Access Compliance Report

Public Rights-of-Way

Intersection ID: 15070	Main Street: IDEAL_WY	Cross Street: REMOUNT_RD	Location:	N
ADA ID: 30BE0A7F9052	Ramp Type: Perp	Initial Pass/Fail: Fail	Overall Compliance: No	Severity Score: 12.5

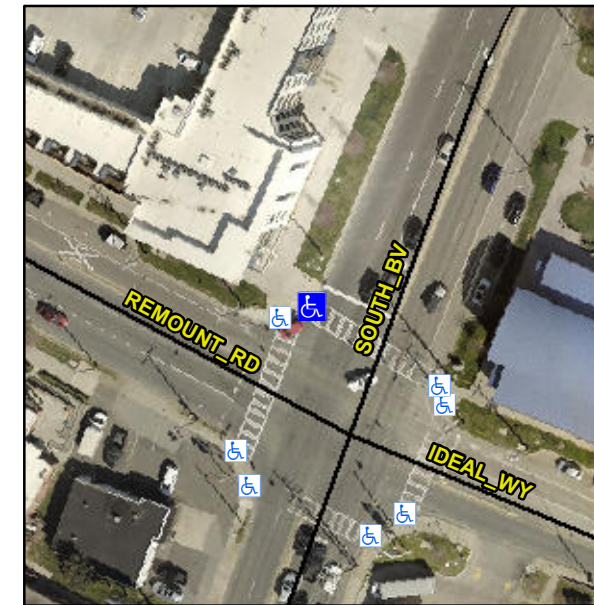
Not Found, R304.2.2

Compliance	Description	Data	Compliance	Description	Data
N/A	Ramp Length (in)	71.0	No	Ramp Slope (%)	9.2
Yes	Ramp Width (in)	49.0	Yes	Ramp XSlope (%)	0.1
N/A	Flare Type LT	N/A	N/A	Flare Type RT	N/A
N/A	Flare Slope LT (%)	N/A	N/A	Flare Slope RT (%)	N/A
N/A	Flare Traversable LT?	N/A	N/A	Flare Traversable RT?	N/A
N/A	Landing Length (in)	N/A	N/A	DWS Provided?	N/A
N/A	Landing Width (in)	N/A	N/A	DWS Contrast?	N/A
N/A	Landing Slope (%)	N/A	N/A	DWS Length (in)	N/A
N/A	Landing X Slope (%)	N/A	N/A	DWS Full Width?	N/A
N/A	Landing Curb? (Y/N)	N/A	N/A	DWS Offset (in)	N/A
N/A	Shared Landing?	N/A			
N/A	Gutter Ponding?	N/A	N/A	Gutter Slope (%)	N/A
N/A	Gutter Lip Ht (in)	N/A	N/A	Gutter X Slope (%)	N/A
N/A	Painted X Walk1?	Yes	N/A	Painted X Walk2?	N/A
	X Walk 1 Direction	To SE		X Walk 2 Direction	N/A
N/A	X Walk 1 Width (in)	122.0	N/A	X Walk 2 Width (in)	N/A
	X Walk 1 Slope (%)	0.0		X Walk 2 Slope (%)	N/A
	X Walk 1 X Slope (%)	0.4		X Walk 2 X Slope (%)	N/A

Remove & Replace Entire Ramp.
